**10.2 Turbine Generator**

The information in this section of the reference ABWR DCD, including all subsections, tables and figures, is incorporated by reference with the following departures and supplements.

**Figure 10.2-1 Turbine Stop Valve Closure Characteristic**

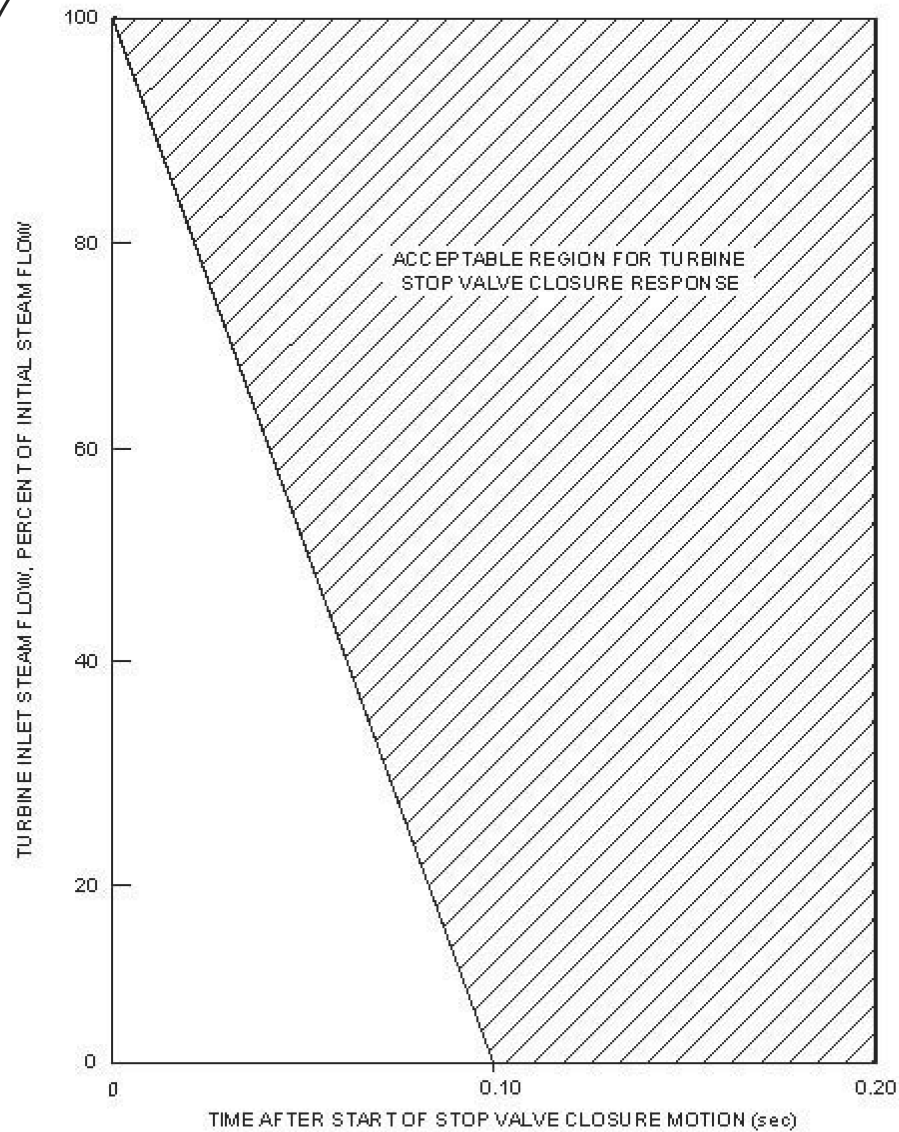
STD DEP Admin (Figure 10.2-1)

Figure 10.2-4 Generator Hydrogen and CO<sub>2</sub> System

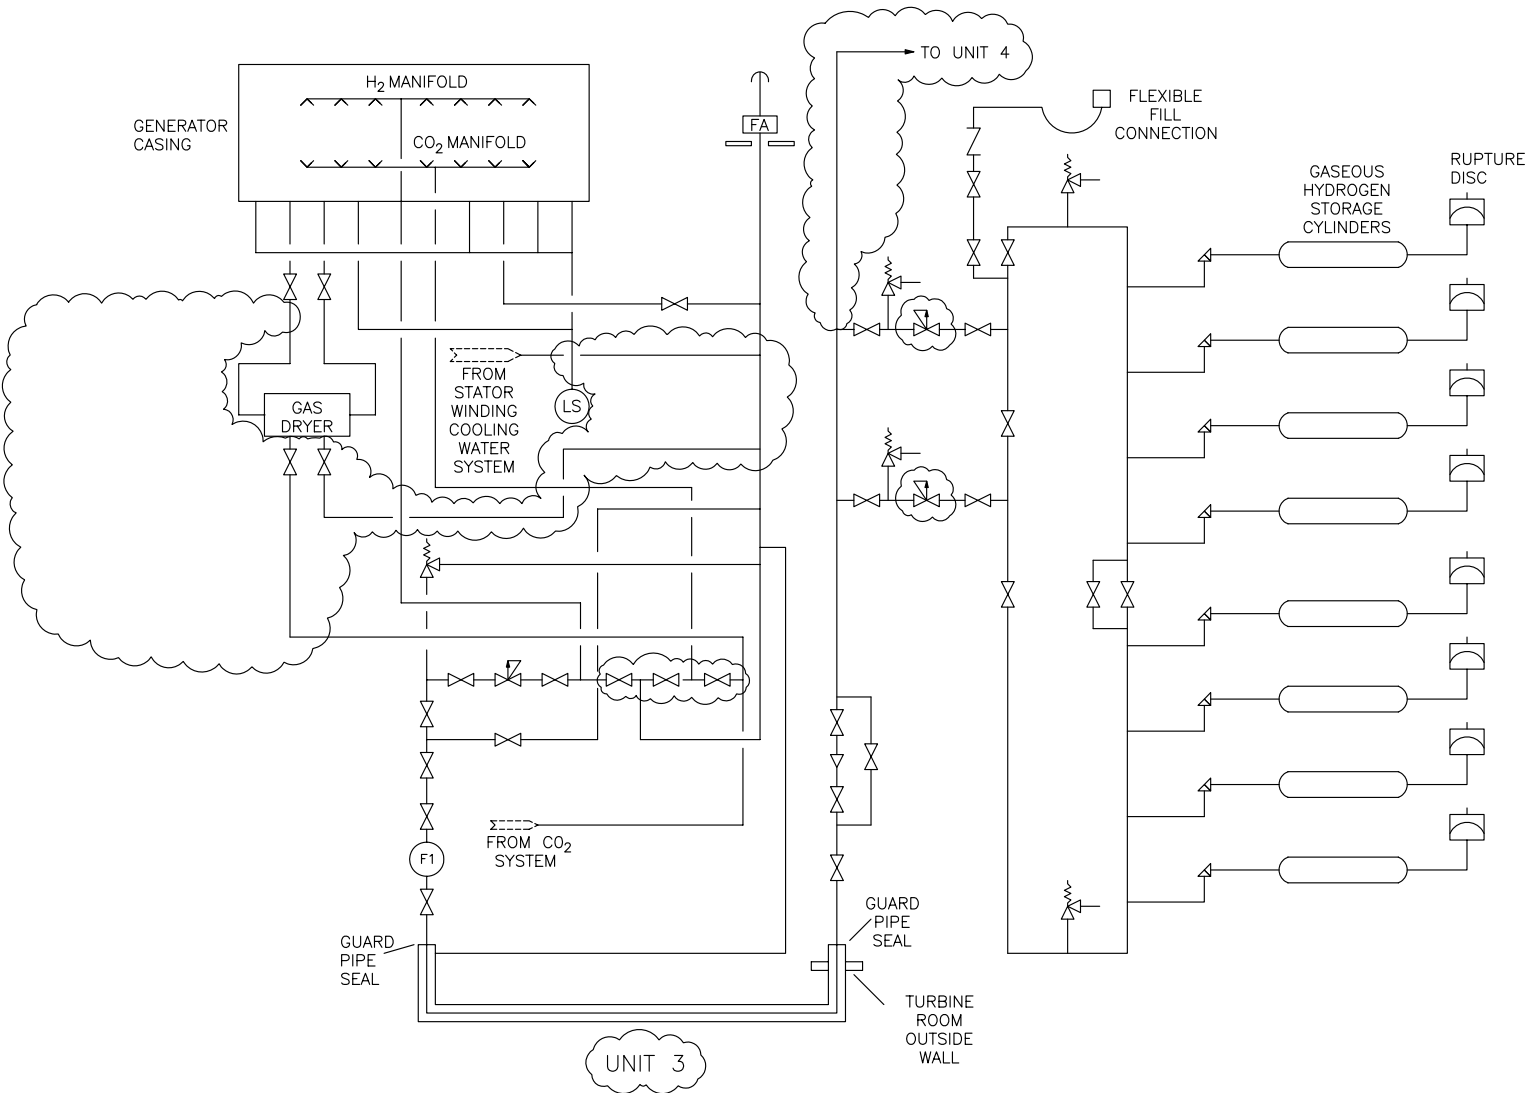
STP DEP 1.1-2 (Figure 10.2-4)

STP DEP 10.2-1 (Figure 10.2-4)

**Bulk Hydrogen System**—*The bulk hydrogen and CO<sub>2</sub> system is illustrated on Figure 10.2-4. The hydrogen system is designed to provide the necessary flow and pressure at the main generator for purging carbon dioxide during startup and supply makeup hydrogen for generator leakage during normal operation.*

storage facility will be used to store hydrogen compressed gas cylinders for STP 3 & 4. The bulk hydrogen storage is located outside ~~but near~~ the Turbine Building and at least 100m from any safety-related building. The hydrogen lines are provided with a pressure reducing station that limits the maximum flow to less than 100 standard cubic meters per minute before entering the Turbine Building. Equipment and controls used to mitigate the consequences of a hydrogen fire/explosion will be designed to be accessible and remain functional during the postulated postaccident condition. The design features and/or administrative controls shall be provided to ensure that the hydrogen supply is isolated when normal building ventilation is lost.

Figure 10.2-5 Turbine Overspeed Trip System Functional Diagram

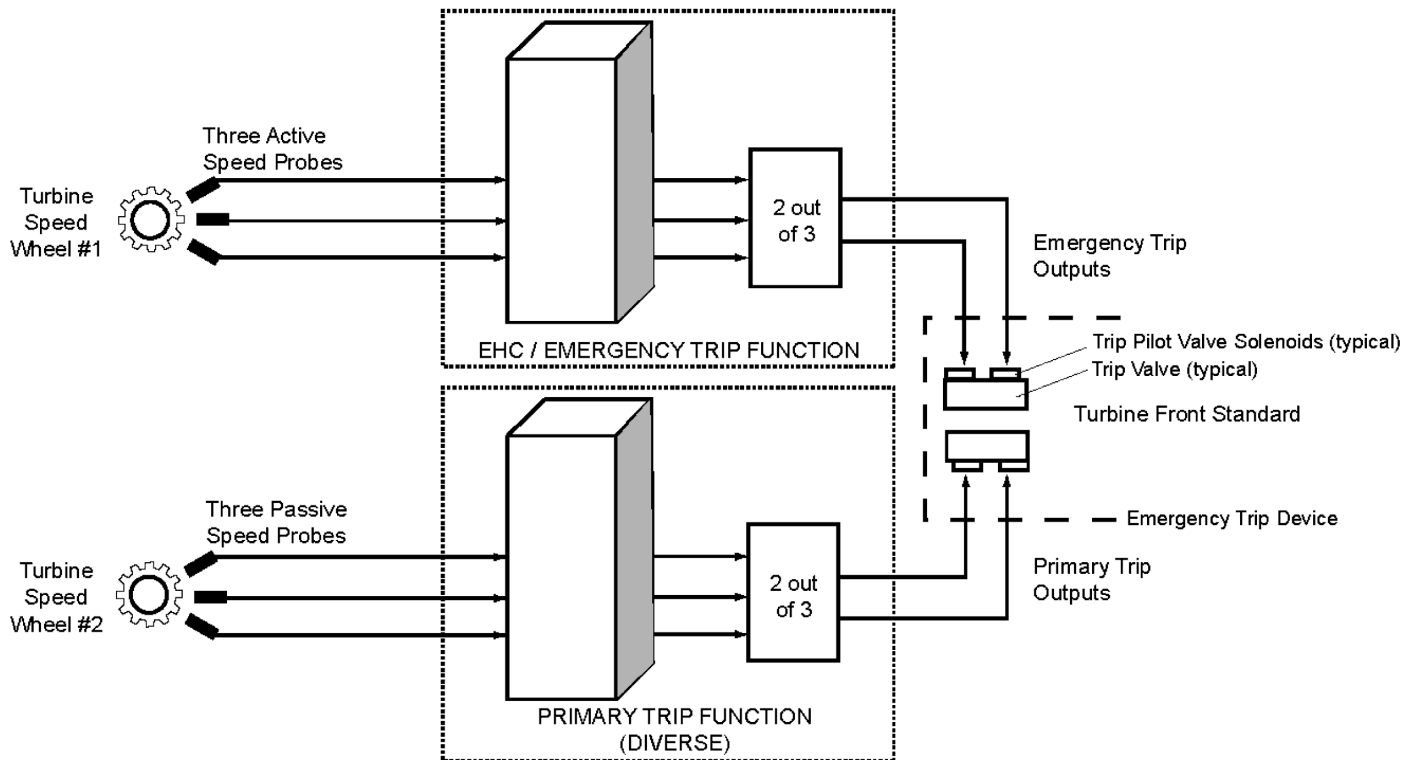
The primary trip function is independent and diverse from the emergency trip function as explained below (refer to Figure 10.2-5, Turbine Overspeed Trip System Functional Diagram). Two-out-of-three logic is employed in both the primary and emergency overspeed trip circuitry. Each trip function can de-energize its associated trip pilot valve solenoids of the electro-hydraulic Emergency Trip Device (ETD). The ETD is composed of two independent trip valves, each with two normally energized fail-safe solenoids. For each trip valve, each trip pilot valve solenoid is powered from a separate power source. The solenoids de-energize in response to detection of an overspeed condition by the turbine speed control logic. De-energization of both trip pilot valve solenoids is necessary to cause the spool in their respective trip valve to reposition, which depressurizes the emergency trip fluid system, rapidly closing all steam inlet valves and indirectly closing the steam extraction nonreturn valves. Accordingly, the repositioning of only one of the two trip valves is necessary to trip the main turbine. A single electrical component failure does not compromise trip protection, and does not result in a turbine trip. Each trip valve in the ETD is testable while the turbine is in operation.

The diverse primary overspeed trip function utilizes three passive speed sensors that are separate from the active speed sensors used for normal speed control and emergency trip function. Speed sensors are diverse (passive and active sensors) between primary overspeed and emergency overspeed trip. Speed sensing for primary and emergency overspeed trip functions also use separate speed wheels (refer to Figure 10.2-5). Each speed signal for the primary trip function is compared to a speed

setpoint of approximately 110% of rated speed, and produces trip signals arranged in two-out-of-three logics, to de-energize both trip pilot valve solenoids of one of the two trip valves of the ETD. Both trip pilot valve solenoids must be de-energized to trip the associated trip valve. The ETD has two redundant trip valves. Tripping of either redundant trip valve will drain the emergency trip fluid, resulting in a turbine trip.
